## JOINT REGIONAL PLANNING PANEL (Sydney East Region)

| <b>JRPP NUMBER:</b>  | 2015 SYE 016  |
| <b>DA NUMBER:</b>  | LDA2015/0018  |

## Assessment Report and Recommendation

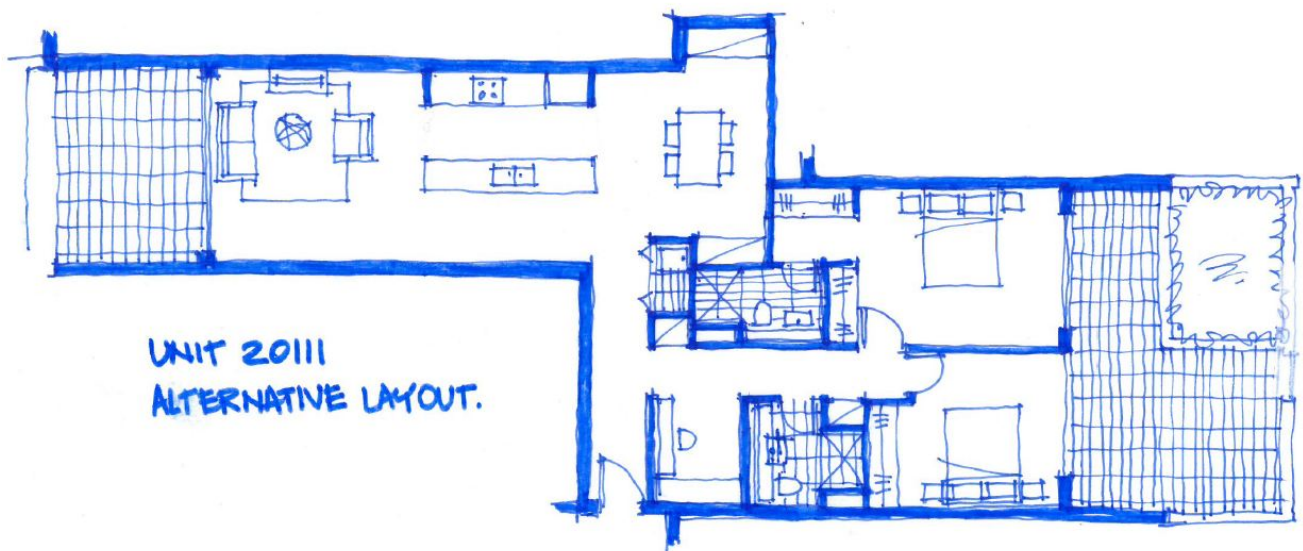
- *Unit 20111*
  - *Larger unit area results in deep floor plans with larger proportion of the internal floor space buried deep in the building away from daylight and natural ventilation.*

- *Privacy conflicts and potential safety issues with the stair landing adjacent the living room balcony*
- *Unit 3042*
  - *Similar to the above unit, the larger unit area results in deep floor plans with larger proportion of the internal floor space buried deep in the building away from daylight and natural ventilation.*

- *Privacy conflicts between bedrooms and adjacent internal corner unit balconies require privacy screens, which further diminish the daylight access to the unit.*

- *Path of travel for ventilation is convoluted and facilitation of cross air movement is hindered.*
- *Unit 20413*
  - *Internal corner unit with limited aperture to exterior at balcony edge. Increased window area does not compensate for limited aperture in facade. Bedrooms borrow light from across balcony and have limited outlook.*

- *The Panel questions how this unit achieves the claimed cross ventilation with limited opening to the exterior.*

The two bedroom unit has been replanned (see revised plans revision B) to reduce the depth of the western balcony to increase daylight penetration into the living room. An alternative sketch plan (see below) includes the reduced balcony and provides an alternate layout including reorientation of the bathrooms and kitchen/ dining room. It is considered that the sketch plan is the best alternative to the original plans as it results in a more appropriate floor plan and layout with greater light penetration. A condition will be imposed to ensure that the development is consistent with the alternate layout plan. (See condition number 2).

It is noted that the documentation submitted with the revisions states that privacy screens and plantings will be provided between Apartments 20111 and 20114. It is recommended that details are to be provided by way of condition.

The two bedroom unit has been replanned (see revised plans revision B) to reduce the depth of the eastern balcony to increase daylight penetration into the living room. An alternative sketch plan (see below) includes the reduced balcony and provides an alternate layout including reorientation of the bathrooms and kitchen/ dining room. As per Unit 20111 it is considered that the sketch plan is the best alternative to the original plans as it results in a more appropriate floor plan and layout with greater light penetration and a more direct path for ventilation. A condition of consent will be imposed to ensure that the development is consistent with the alternate layout plan. (See condition number 2).
